City of Mississauga Department Comments

Date Finalized: 2022-01-19	File(s): A17.22 Ward 11
To: Committee of Adjustment	
From: Committee of Adjustment Coordinator	Meeting date:2022-01-27 1:00:00 PM

Property Address: 6147 Duford Drive

Appendix 1 – Transportation and Works Comments

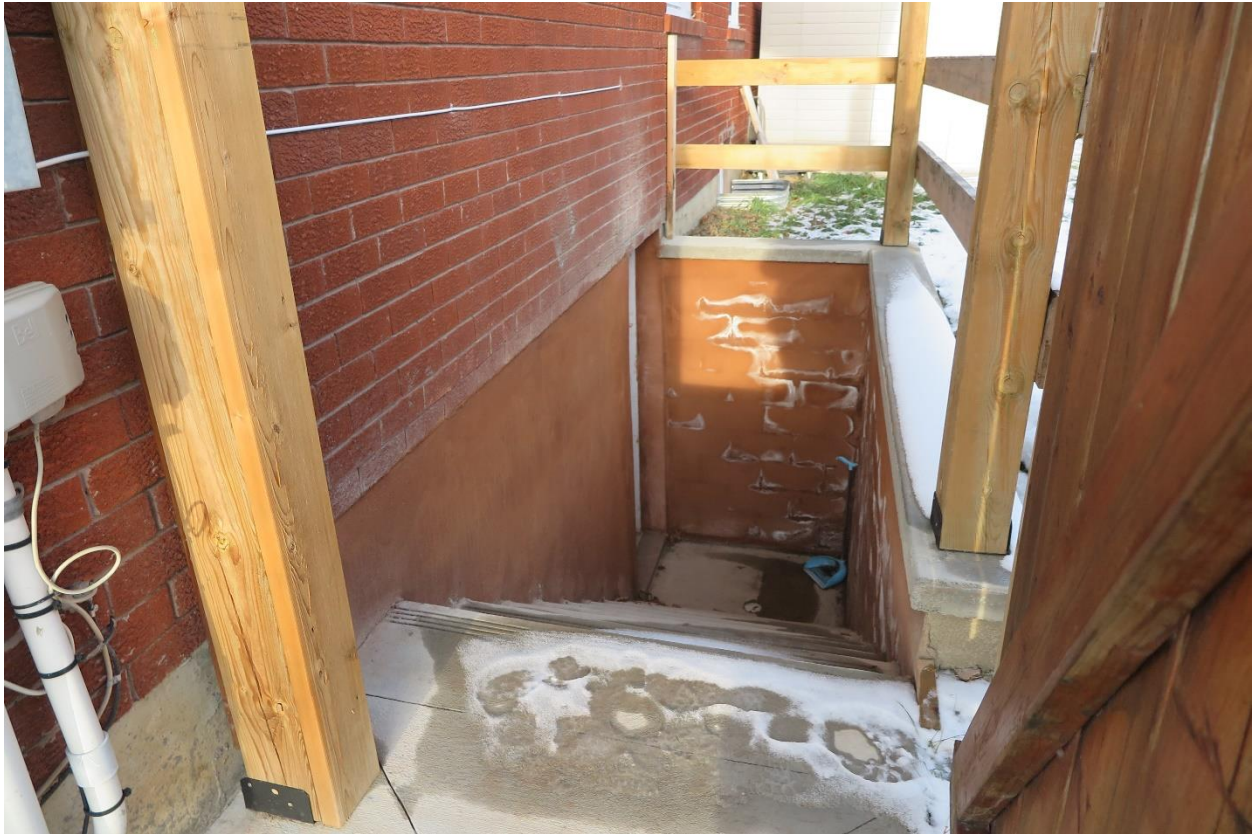
As this is a corner lot, this department foresees no drainage related concerns with the location of the existing pedestrian entrance.
